Access Compliance Report

Public Rights-of-Way

(Curb Ramps)

Intersection ID: 44470	Main Street: COREY_COMMON_AV	Cross Street: NEWFIELD_ST	Location: E
ADA ID: 73182BFBF69D	Ramp Type: BlendTrans1	Initial Pass/Fail: Fail	Overall Compliance: No
Severity Score: 8.75			
Codes/Mitigation Info/Possible Solution		Field Measurements/Component Compliance

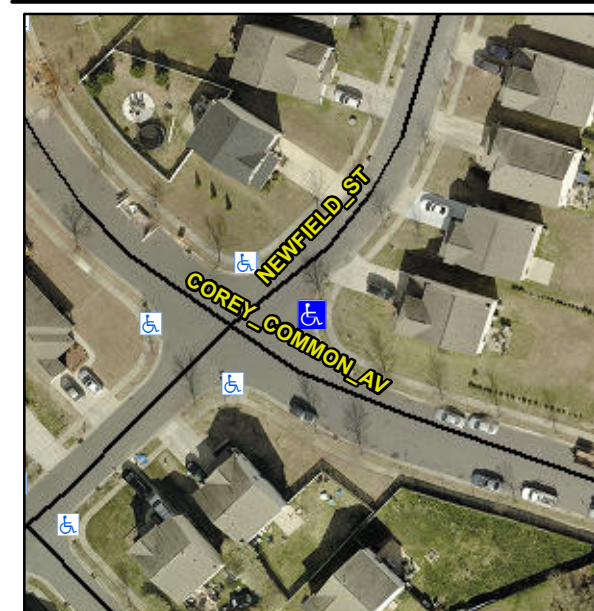
Not Found, R304.5.1

Compliance	Description	Data	Compliance	Description	Data
N/A	Ramp Length (in)	46.0	Yes	BlendTrans Slope (%)	4.0
No	Ramp Width (in)	45.0	Yes	BlendTrans XSlope (%)	1.7
N/A	Flare Type LT	N/A	N/A	Flare Type RT	N/A
N/A	Flare Slope LT (%)	N/A	N/A	Flare Slope RT (%)	N/A
N/A	Flare Traversable LT?	N/A	N/A	Flare Traversable RT?	N/A
N/A	Landing Length (in)	N/A	N/A	DWS Provided?	N/A
N/A	Landing Width (in)	N/A	N/A	DWS Contrast?	N/A
N/A	Landing Slope (%)	N/A	N/A	DWS Length (in)	N/A
N/A	Landing X Slope (%)	N/A	N/A	DWS Full Width?	N/A
N/A	Landing Curb? (Y/N)	N/A	N/A	DWS Offset (in)	N/A
N/A	Shared Landing?	N/A			
N/A	Gutter Ponding?	N/A	N/A	Gutter Slope (%)	N/A
N/A	Gutter Lip Ht (in)	N/A	N/A	Gutter X Slope (%)	N/A
N/A	Painted X Walk1?	No	N/A	Painted X Walk2?	No
	X Walk 1 Direction	To NW		X Walk 2 Direction	To SW
	X Walk 1 Width (in)	N/A		X Walk 2 Width (in)	N/A
	X Walk 1 Slope (%)	1.3		X Walk 2 Slope (%)	1.7
	X Walk 1 X Slope (%)	1.0		X Walk 2 X Slope (%)	0.7

N/A	Ramp inside XWalk1?	N/A	N/A	Ramp inside XWalk2?	N/A
	Road Slope (%)	1.0		Clear Space?	N/A
	Road X Slope (%)	1.5	N/A	Clear Space to XWalk (in)	N/A
N/A	Any Obstructions?	N/A	N/A	Storm Grate/Utility Hazard?	N/A
	Obstruction Type			Storm Grate/Utility Type	
		N/A			N/A
			Yes	Surface Condition? (G/P)	Good
			No	Curb Slope (%)	6.7

Remove & Replace Curb Ramp With Two New Directional Ramps or Equivalent.
